Subject: Oyster Creek Generating Station
Facility Operating License No. DPR-16
NRC Docket No. 50-219

Technical Specification Change Request No. 328 – Modify Surveillance
Requirements for Testing of Main Steam Line Electromatic Relief Valves

Oyster Creek Technical Specification Change Request No. 328

Evaluation of Proposed Change

Figure 1

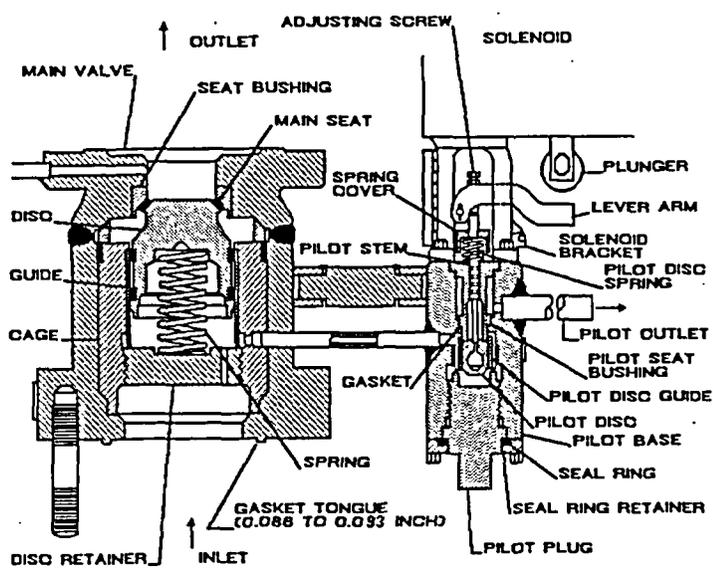
There are five Dresser EMRVs, model 1525VX, on the main steam lines between the reactor vessel and the main steam line isolation valve within the drywell. The EMRVs consist of a main valve assembly, pilot valve assembly, and a solenoid actuator (see Figure 1). The EMRVs are opened by automatic or manual switch actuation of a solenoid. When energized the solenoid actuates the plunger, which pushes down the pilot valve operating lever, thereby opening the pilot valve. When the pilot valve opens, pressure under the main valve disc is vented. This results in an unbalanced steam pressure across the main disc, which moves the main disc downward from its seat thereby opening the main valve.

The alternative test will be performed with the solenoid actuator mounted in its normal position. This will allow testing of the manual actuation electrical circuitry, solenoid actuator, pilot operating lever, and pilot valve assembly. This test will verify pilot valve movement. However, since this test will be performed in the absence of the reactor pressure needed to overcome main valve closure spring force, the main valve will not stroke during the test. Stroking the pilot valve in the absence of steam pressure is referred to as "dry cycling."

The proposed OCGS valve actuator testing will include manual dry cycling of the pilot valve to verify that the stem travel and lever arm adjusting screw gap are within limits. Following this verification, the EMRV solenoid will be energized to stroke the pilot valve. The stem travel and lever arm adjusting screw gap will then be rechecked to verify that these parameters are within limits following the dry cycling. Partial disk-stem separation caused by dry cycling of the pilot valve would be detected during this recheck. The EMRV manufacturer, Dresser, concluded that this recheck would detect partial disk-stem separation caused by dry cycling of the pilot valve. In addition, dry cycling of the pilot valves has been performed on the EMRVs at the Dresden and Quad Cities Nuclear Power Stations for many years, with no signs of partial or full disc detachment. Therefore, the proposed testing is adequate to detect the partial disk-stem separation experienced at NMP-1.
